PRIVATE PLAN CHANGE 94
HEARING REPORT VOLUME 1
WAIRAKA PRECINCT IN CARRINGTON ROAD,
MT ALBERT
MINISTRY OF HOUSING AND URBAN
DEVELOPMENT – HANNAH MCGREGOR

Hearing Report for Proposed Private Plan Change 94: Wairaka Precinct to the Auckland Unitary Plan (Operative in part)

Report to:	Hearing Commissioners
Hearing Dates:	18 – 22 November 2024
File No:	Hearing Report – Proposed Private Plan Change 94
File Reference	U:\CPO\RLP\FC\LUP\UP MODIFICATIONS\PC094
Report Author	Peter Reaburn, Consultant Planner
Report Approver	Celia Davison
Report produced	4 October 2024

Figure 11 Height Areas Plan

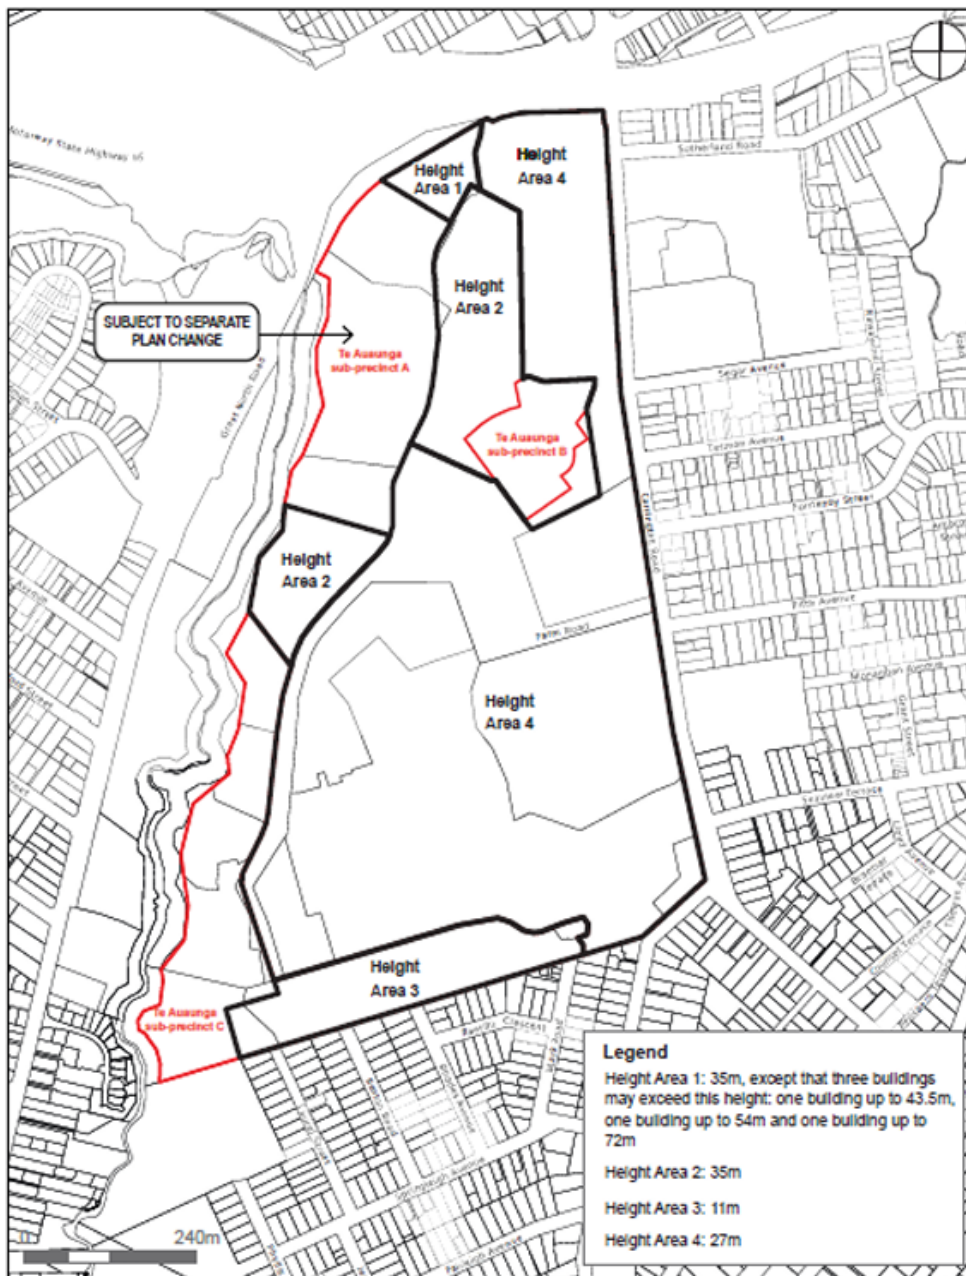
145. In respect of height, four height areas are proposed as shown on Figure 11 below. These replace the current height provisions (see the existing / proposed comparison given in the Analysis below).

146. A new activity category provides for departures from these heights as a Restricted Discretionary Activity. A discrete category, also as a Restricted Discretionary Activity, would apply to buildings within Height Area 1 between 35m and 72m. Matters of discretion and assessment criteria are proposed.
147. Part 10 of the AEE gives a s32 evaluation of the changes in heights, including the consideration of options. As part of this evaluation the AEE states:

209. I accordingly recommend that the tower components of Height Area 1 not be allowed. That area should be incorporated in Height Area 2, i.e. a 35m height.

Figure 13 Volcanic (Maunga) Viewshaft A13

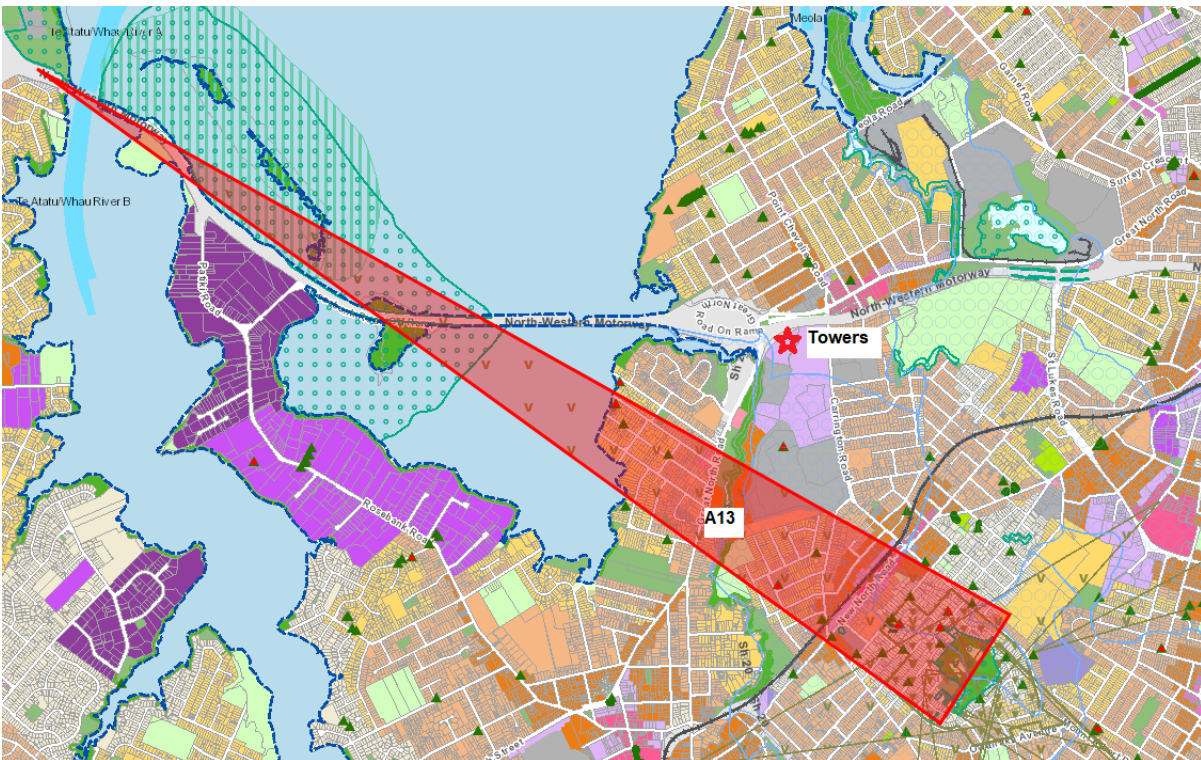
207. If the reasoning for towers in this location is to solely to create a landmark I consider that does need to be considered alongside other landmarks already existing in the area. Mr Brown raises a concern about the towers competing with views to Mt Albert from the North-western Motorway as it approaches Pt Chevalier. An overlay objective in D14.2. is that:

- (1) The regionally significant views to and between Auckland's maunga are protected.
208. The adopted method in the AUP is to manage buildings within a viewshaft. I would not ordinarily consider views of a maunga to be given much weight where buildings were outside a viewshaft. In this case, as shown on Figure 13, the A13 viewshaft to Mt Albert is some distance to the south. However Mt Albert is still a natural landmark and I note Mr Brown's opinion that, for towers of a height considerably higher than is envisaged, consideration of other landmarks is a relevant consideration.

Figure 16 Proposed Precinct Plan

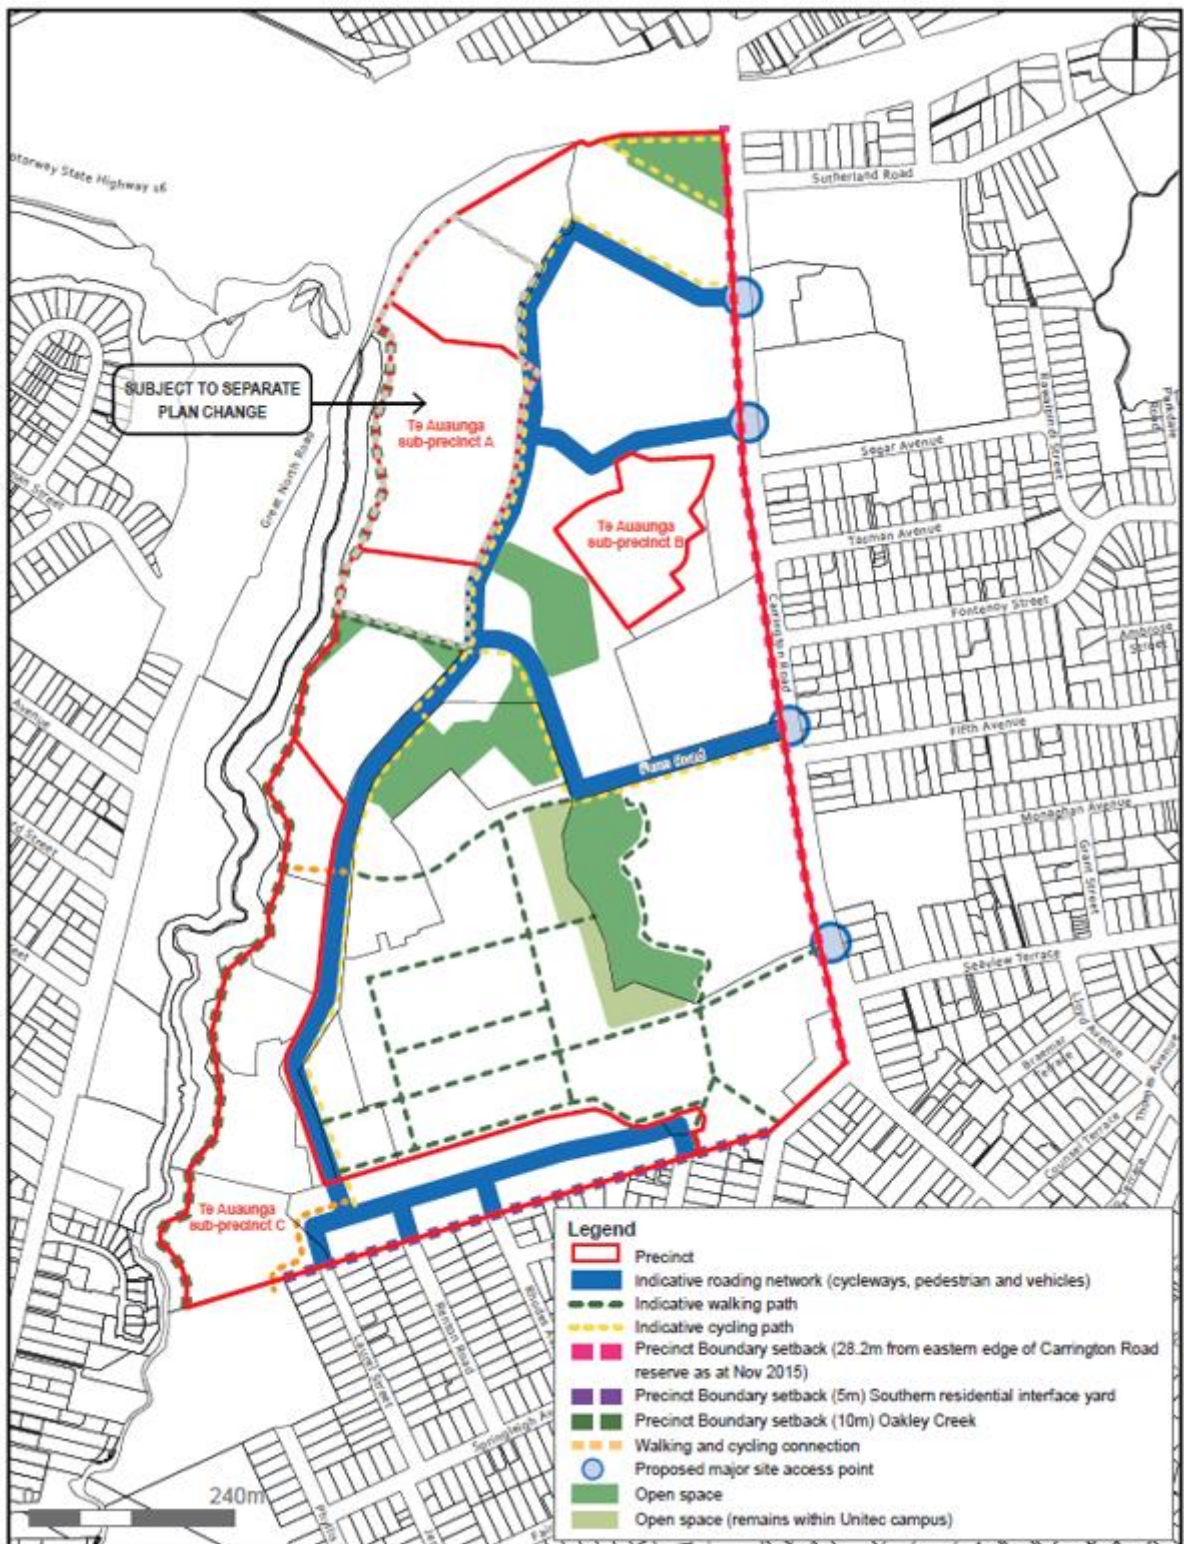
228. In respect of open space the current Key open space (private) areas have become, simply, "Open space", with an area to remain in the Unitec campus separately identified. The PC75 Key private open space (private) is no longer shown, nor the current neighbourhood reserve. Other areas, including the Knoll and Southern Open Space, have been reduced in size. A Central Open Space area, an access to Te Auanga Creek and an area north of the Oakley Hospital have been added. These changes are explained in more detail in the Analysis below.

Figure 17 Mega-lot Subdivision

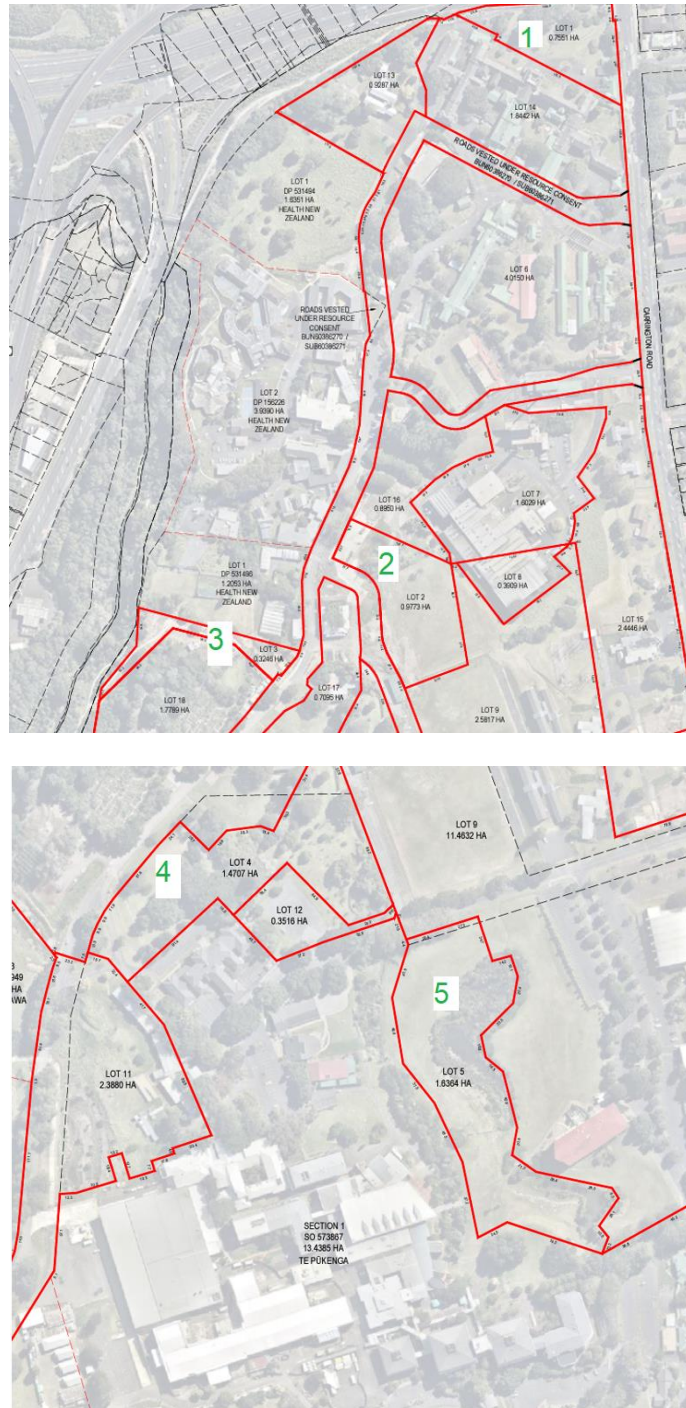
239. The approved mega-lot subdivision consent contains lots that reflect the revised intentions on the proposed PC94 precinct plan for open space areas. The mega-lot plans, with relevant lots marked, are in Figure 17 below. I note that the site areas cannot be picked up at the scale of the plans recorded below, however they do appear in the comparison table below.

240. It is noted that Lot 5 does not include a 1.02ha area⁴⁶ of Key open space (private) land that is shown on the current precinct plan but is now to be allocated to the “balance” Unitec site. It is however shown on the revised PC94 precinct plan.
241. I have copied Table 4 from Mr Greenaway’s Specialist Review below. This table gives an analysis of existing and proposed areas of open space, noting that the Mason Clinic Area is referred to in Policy 15A, introduced by PC75, as being replaced elsewhere in the precinct. I also note that it does not include 0.6ha for stormwater reserve which is part of
